Subject: Public Comment re. Spieker Proposal

This is Public Comment on the Draft EIR for County File # CDGP20-00001, CDRZ20-03255, CDMS20-00007, CDDP20-03018, & CDLP20-02038, The Spieker Senior Continuing Care Retirement Project

Map Portfolio—Save Seven Hills Ranch

12 Walnut Creek Development Constraints, 15% slope / Alternatives Map

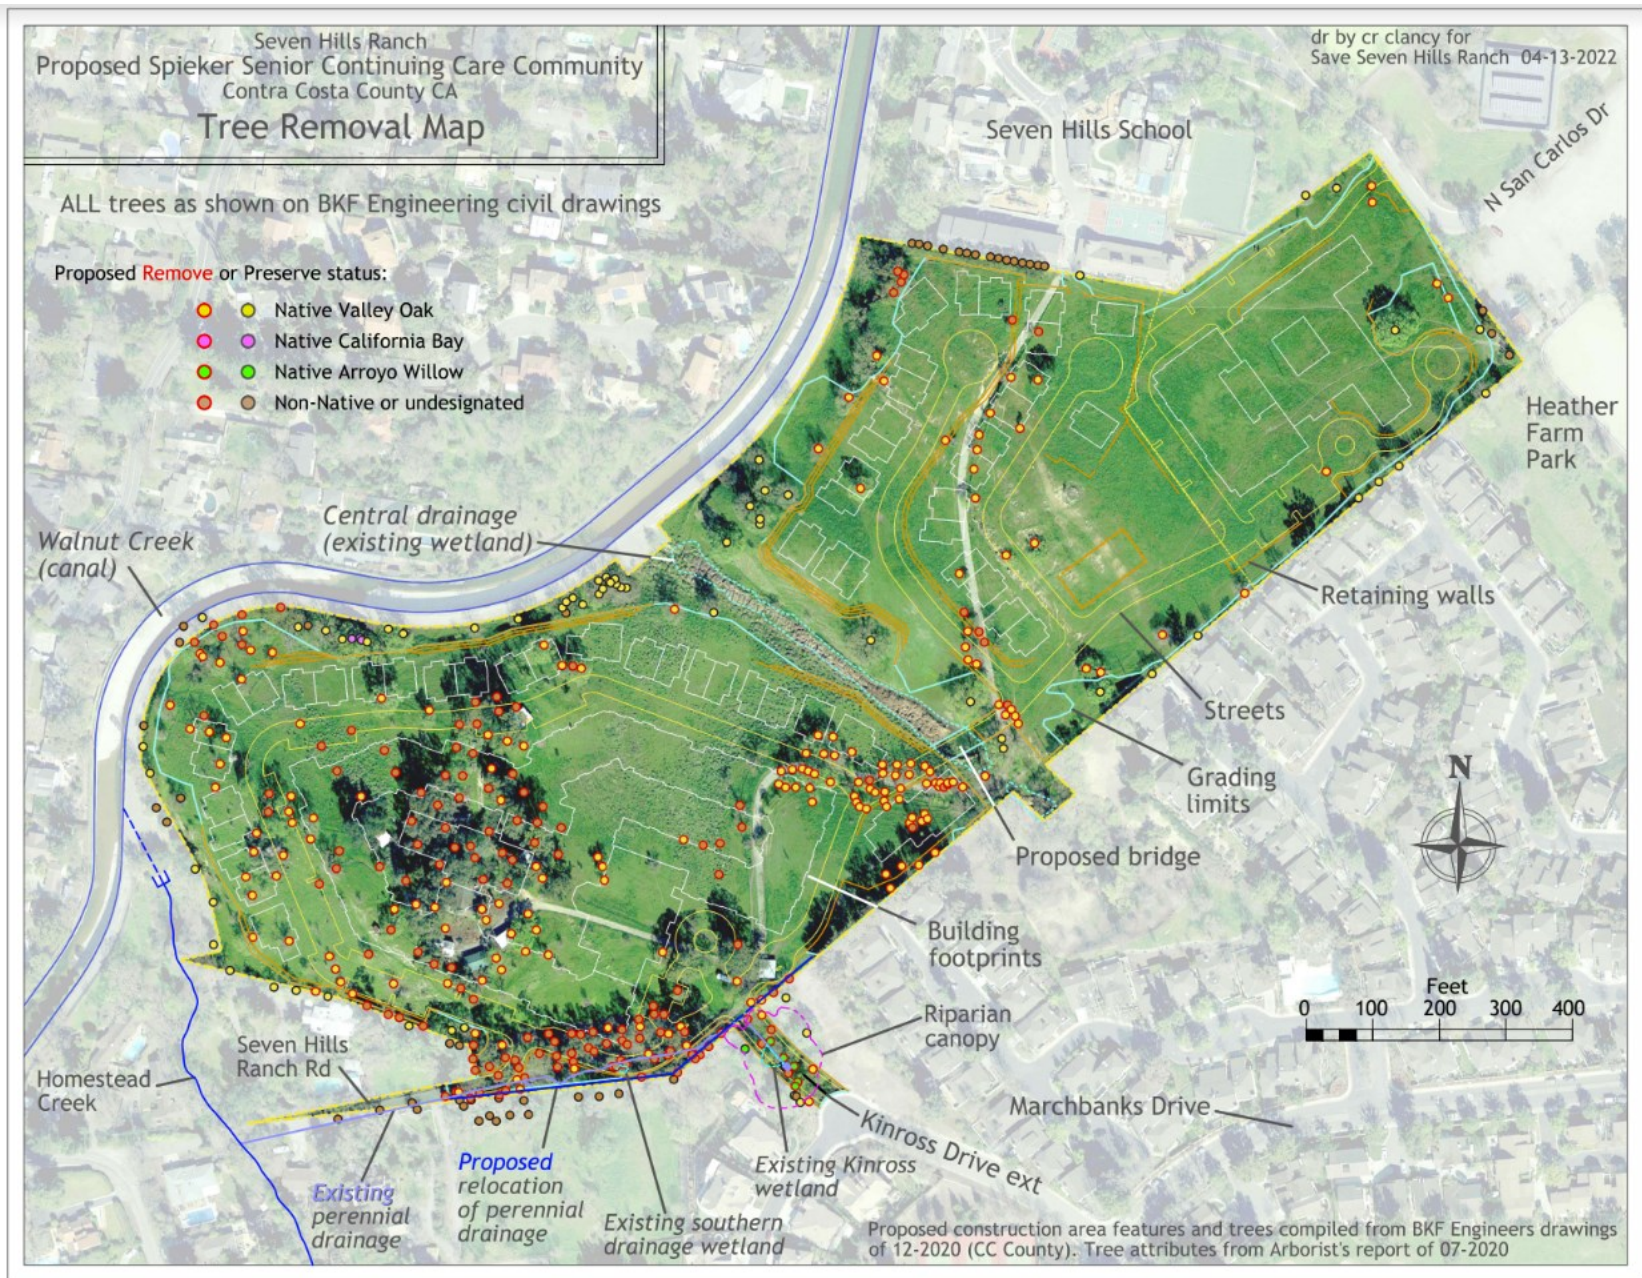
This map shows how much developable land would be available if the Walnut Creek 15% slope code and a limited set of other constraints related to trees and wetlands were applied. Walnut Creek's code is related to average slope and density. The map can help visualize realistic and environmentally respectful Alternative development possibilities.

13 Tree Removal Map

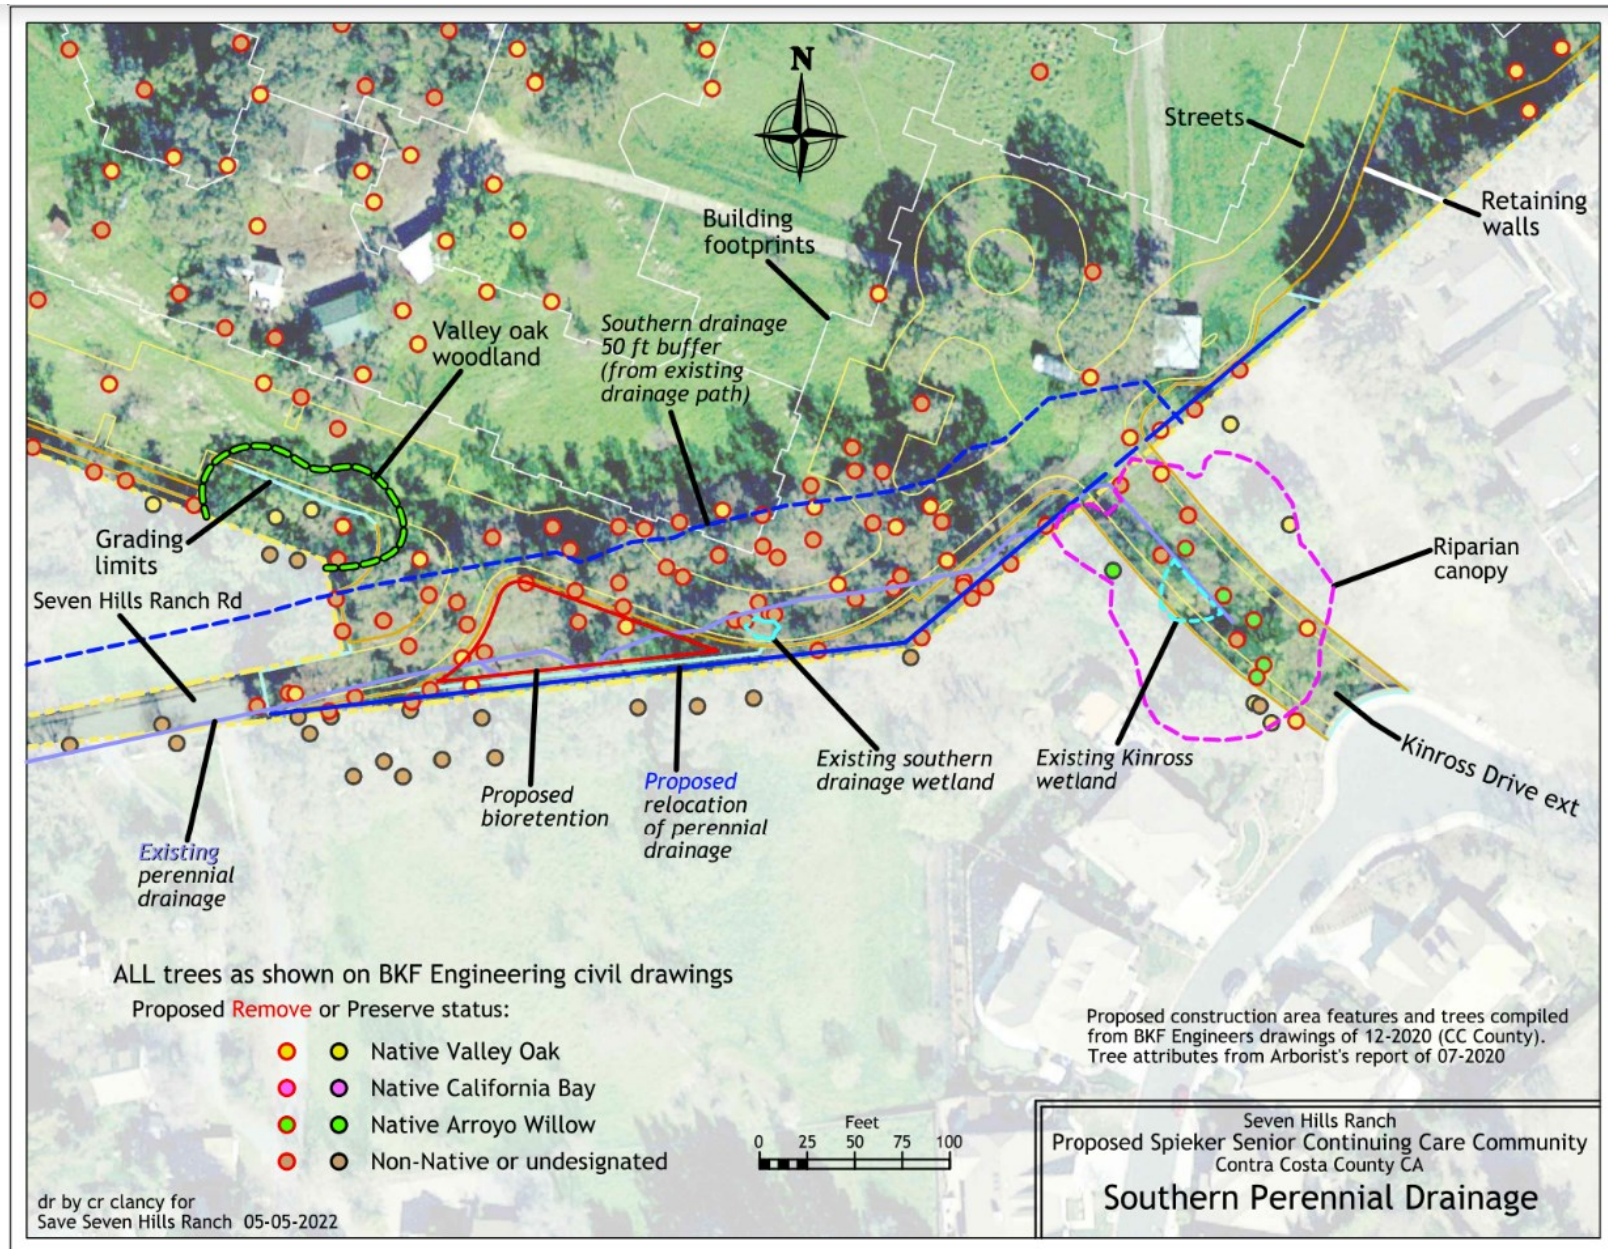
This map shows the distribution of trees to be removed or preserved and indicates which trees are Native. This map also serves as context for the status and plans for Central and Southern wetlands and drainage.

14 Southern Perennial Wetlands/Drainage Map

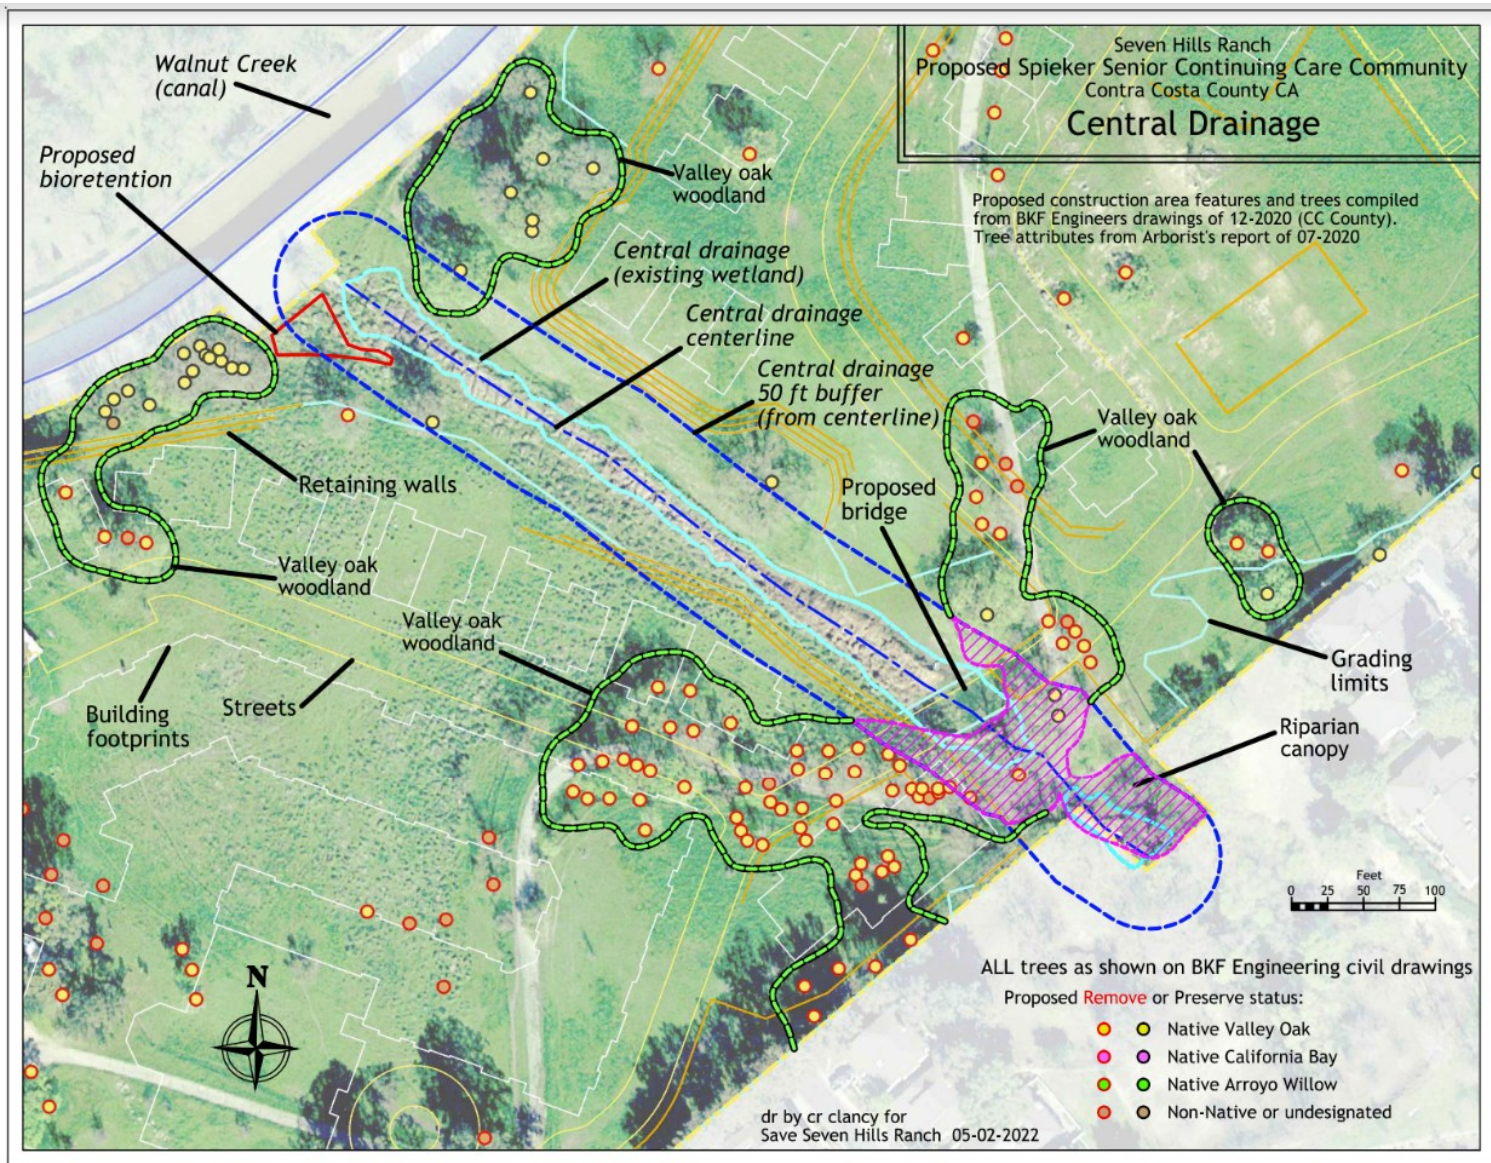
This map details the current and potential future status of trees, wetlands and drainage in the Southern Perennial Wetlands/Drainage area, which includes the proposed Kinross Extension. An added feature is existing Valley Oak Woodlands, which were not defined in the arborist's report.

15 Central Wetlands/Drainage Map

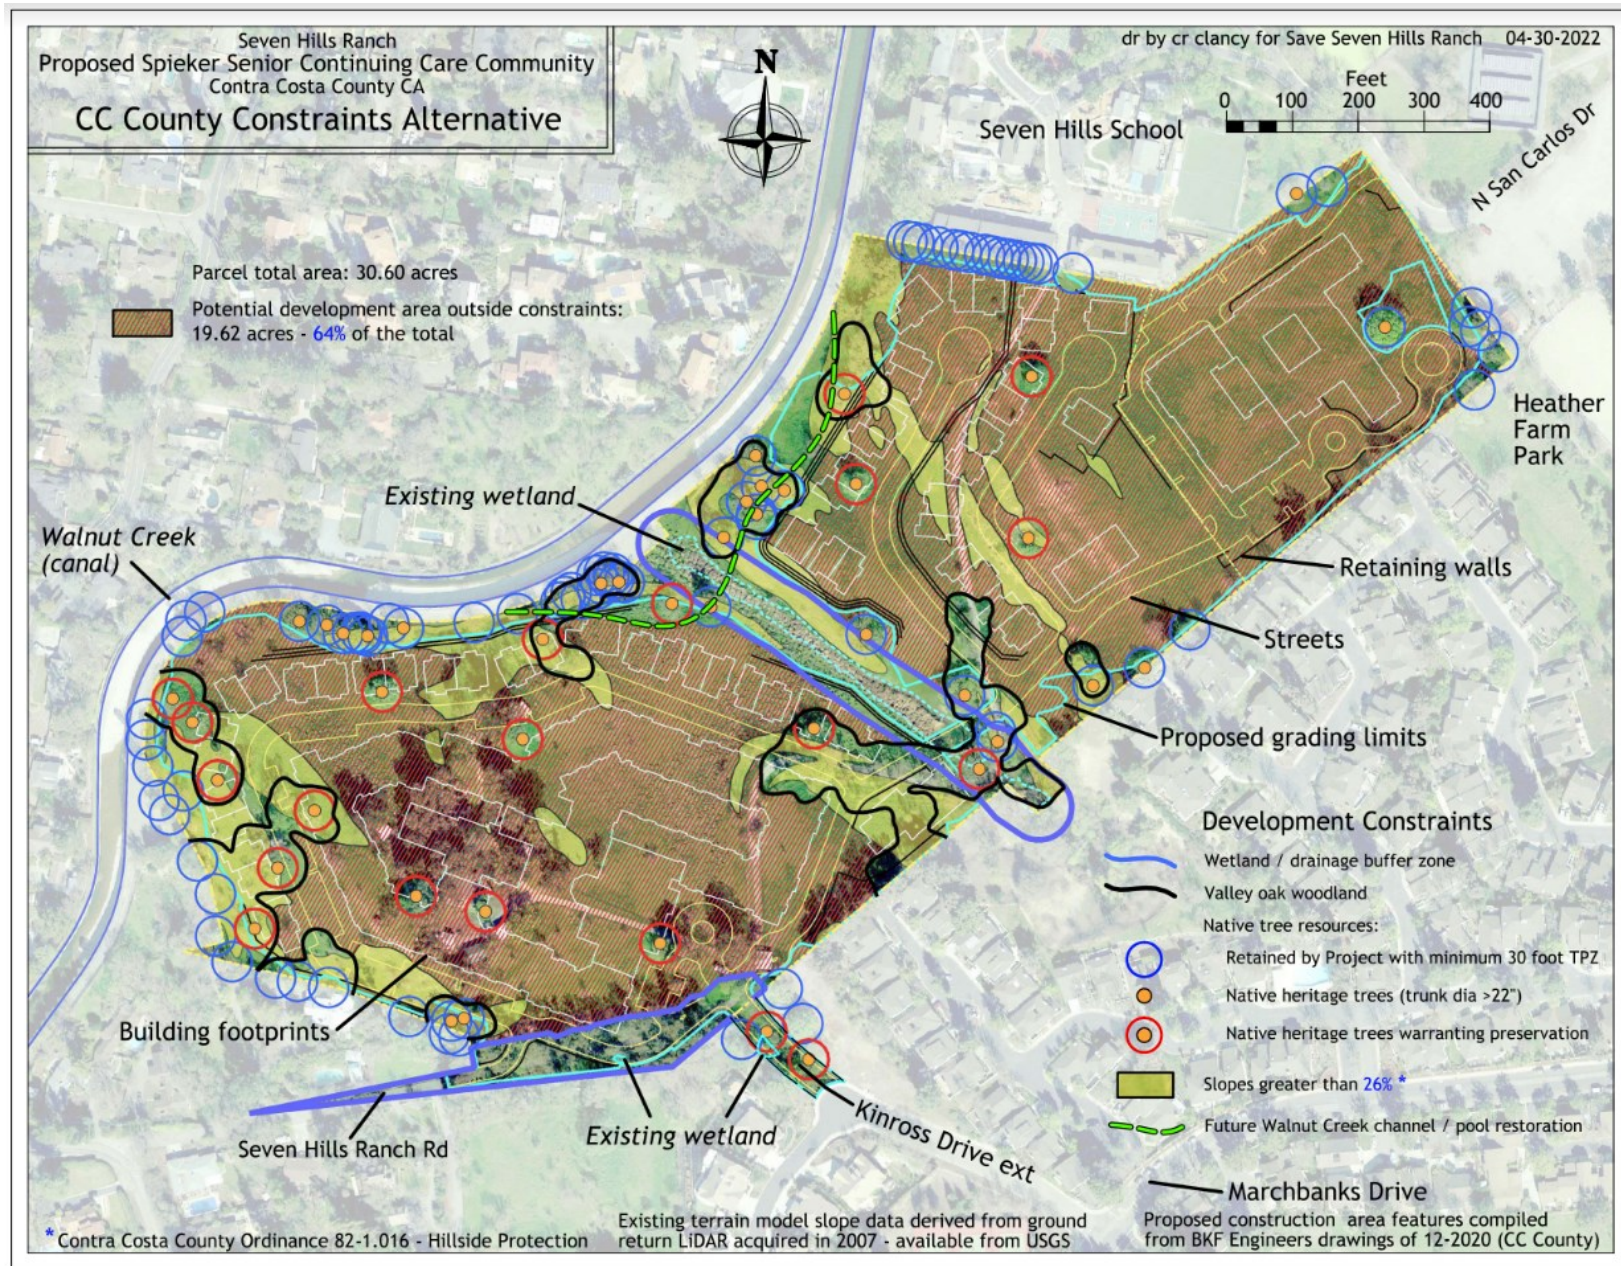
This map details the current and potential future status of trees, wetlands and drainage in the Central Wetland/Drainage. An added feature is Valley Oak Woodlands which were not defined in the arborist's report.

16 All Constraints (Contra Costa County: 26% slope) / Alternatives Map

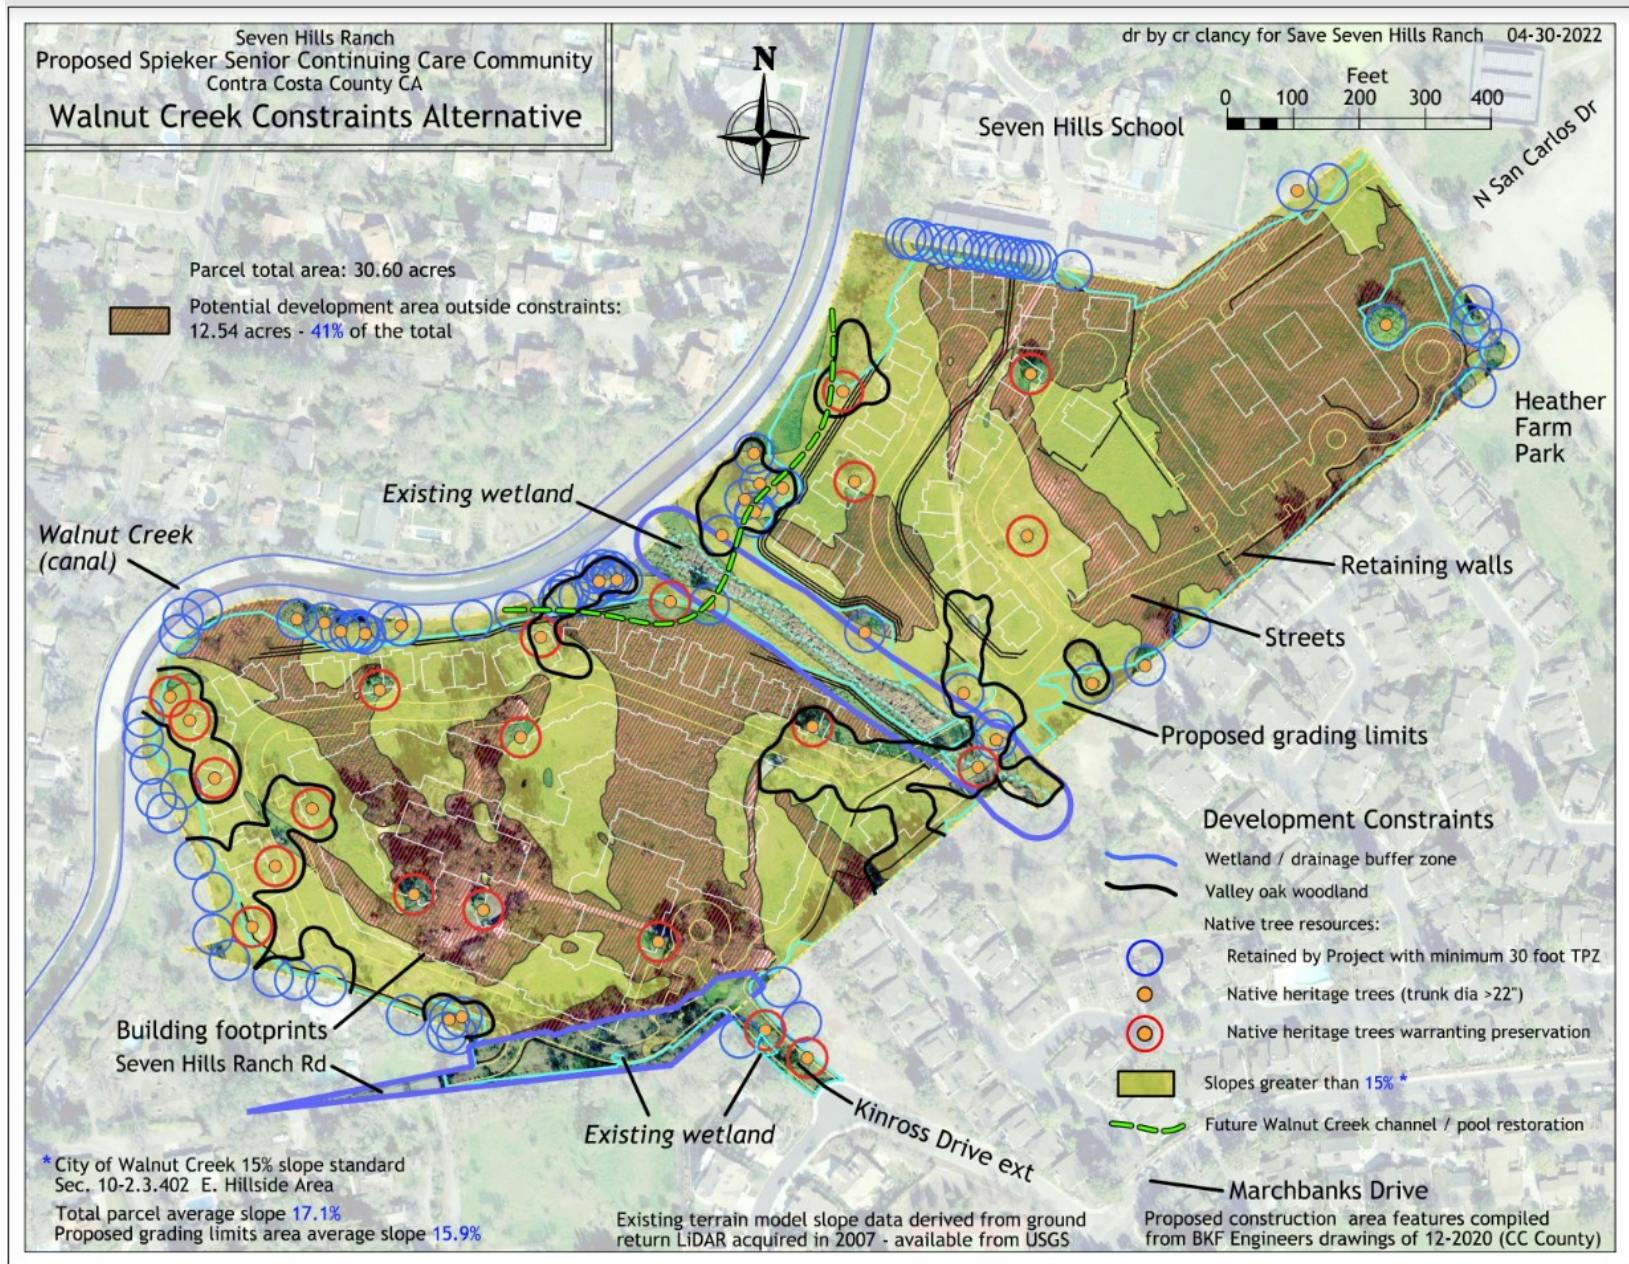
This map shows the potential development area after all foreseeable constraints have been applied: slopes greater than 26%, preserved tree buffers, wetland buffers, Valley Oak Woodlands, and a Walnut Creek channel restoration setback. Aids to visualize the possibilities for alternative development.
